Oaks at Skybrook North Subdivision Sketch Plan

PART 1: PROJECT SUMMARY

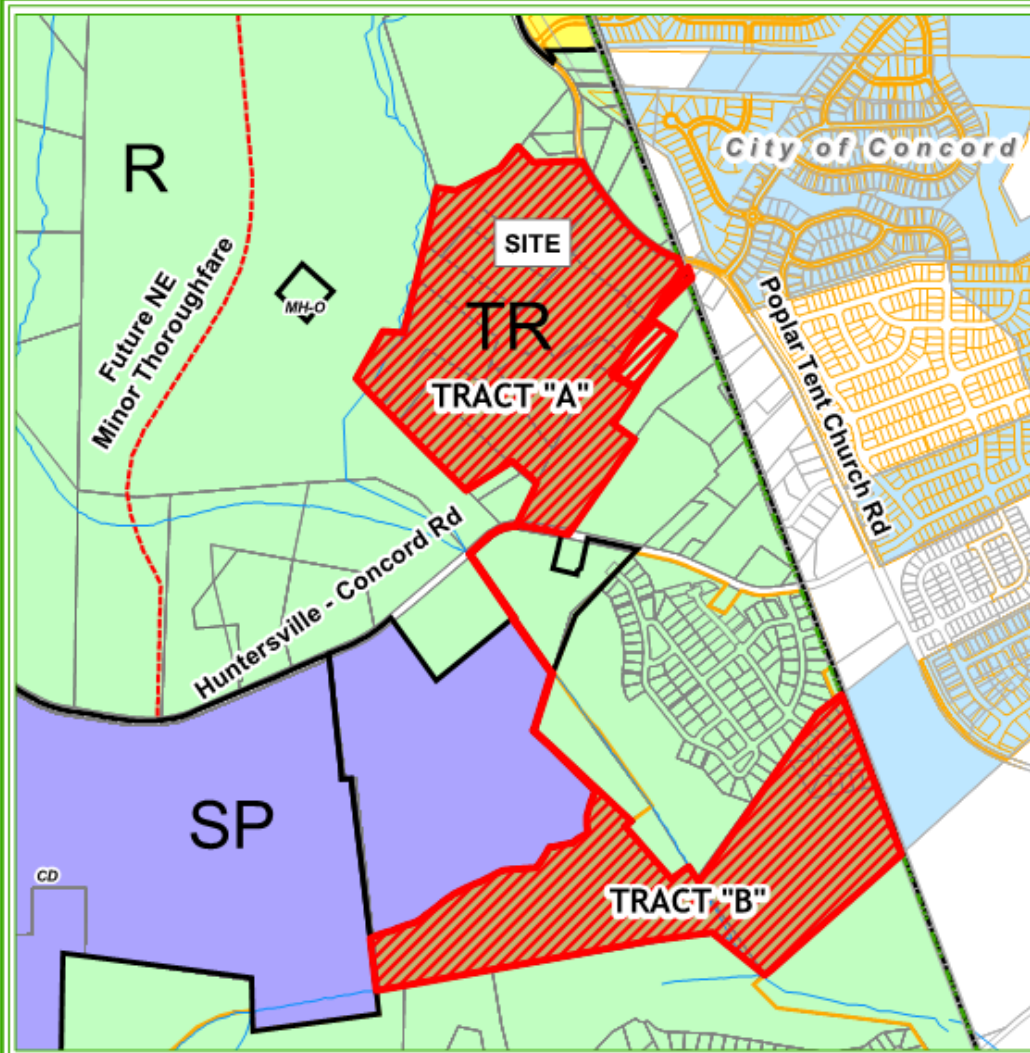
1. Purpose: To REVISE an conditional district rezoning and sketch plan for 175.05-acres of land located north of Huntersville-Concord Road and west of Poplar Tent Church Road, near the Cabarrus County line (north of Parkside at Skybrook Subdivision), shown as Tract A, above.
It is important to understand that Oaks at Skybrook North, as a whole, includes 175.05-acres broken-out into Tracts A & B. ALL OF THE PROPOSED CHANGES ARE FOR TRACT A ONLY. The addition of a new parcel, street layout changes, open space adjustments and other revisions are all on Tract A. There are no revisions proposed for Tract B.
A revised Conditional District Rezoning Plan for this project has also been submitted concurrent with this Sketch Plan and was reviewed by the Planning Board on June 27 and July 25, 2017.
